Project	IEEE 802.16 Broadband Wireless Access Working Group < http://ieee802.org/16 >	
Title	Enhancement of DL Map transmission with STC in the first mandatory PUSC zone	
Date Submitted	2005-03-14	
Source(s)	Jason Hou, Sean Cai, Mary Chion, Jing Wang	jhou@ztesandiego.com scai@ztesandiego.com mchion@ztesandiego.com jwang@ztesandiego.com
	ZTE San Diego 10105 Pacific Heights Boulevard Suite 250, San Diego, CA92121	Tel: 858-554-0387
Re:	Response to Sponsor Ballot on IEEE802.16e/D6 document	
Abstract	STC modulation for first-zone PUSC with DL-MAP and broadcast messages.	
Purpose	Adopting of proposed method into P802.16e D7	
Notice	This document has been prepared to assist IEEE 802.16. It is offered as a basis for discussion and is not binding on the contributing individual(s) or organization(s). The material in this document is subject to change in form and content after further study. The contributor(s) reserve(s) the right to add, amend or withdraw material contained herein.

Enhancement of DL Map transmission with STC in the first mandatory PUSC zone

Jason Hou, Sean Cai, Mary Chion, Jing Wang

ZTE San diego. Inc.

Figure xxx- Cluster structure for First-zone STC.

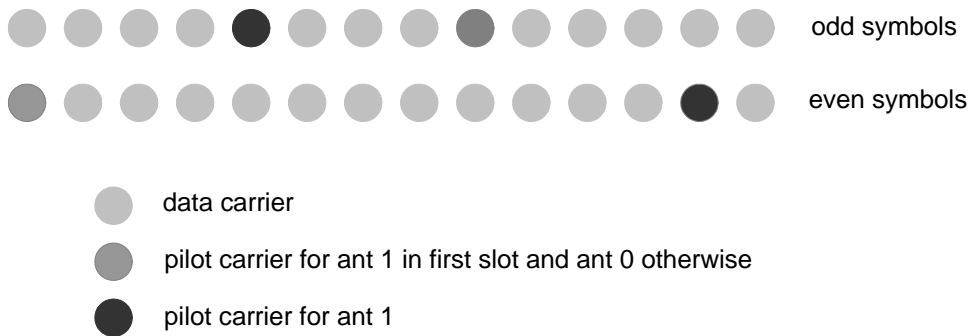
[Add Section 8.4.8.1.2.1.3]

8.4.8.1.2.1.3 First-zone STC modulation using 2 antennae in PUSC

The clusters comprising the subchannels used by the First-zone STC modulation shall be allocated and subcarriers numbered as defined in 8.4.6.1.2.1. The cluster structure is depicted in Figure xxx. With an exception of FCH subchannels, encoding of the First-zone STC is depicted in Figure yyy. The FCH subchannels shall not be STC encoded. The First-zone STC mode is enabled via Coding Indication contained in the DL Frame Prefix (8.4.4.3). For preamble symbols and FCH subchannels transmission, antenna 1 transmits null data in the corresponding data tones. Demodulation of DL Frame Prefix that contained in FCH subchannels is thereby unaffected from the single-antenna TX configuration and is fully compatible with the mandatory PUSC modulation.

Figure yyy. Encoding of STC for use with First-zone PUSC.

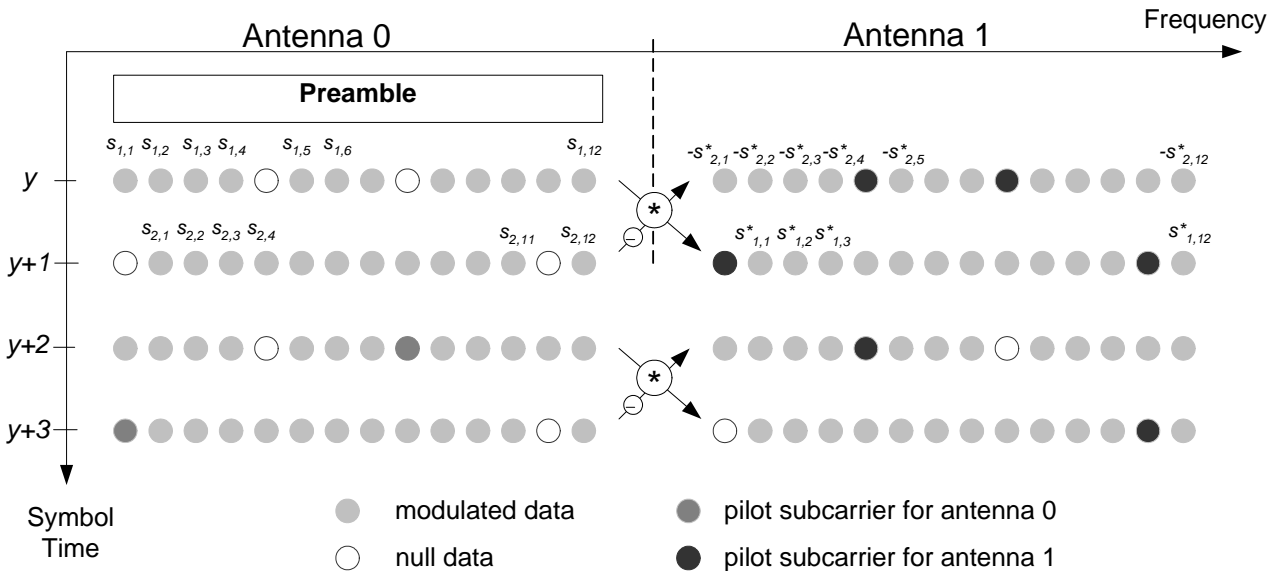
The pilot tones in the first slot (first two OFDMA symbols after the preamble symbol) shall be transmitted by antenna 1 for use in channel estimation. Thereafter the pilot tones are divided between antenna 0 and 1. Modulation of pilot tones are depicted in Figure yyy.
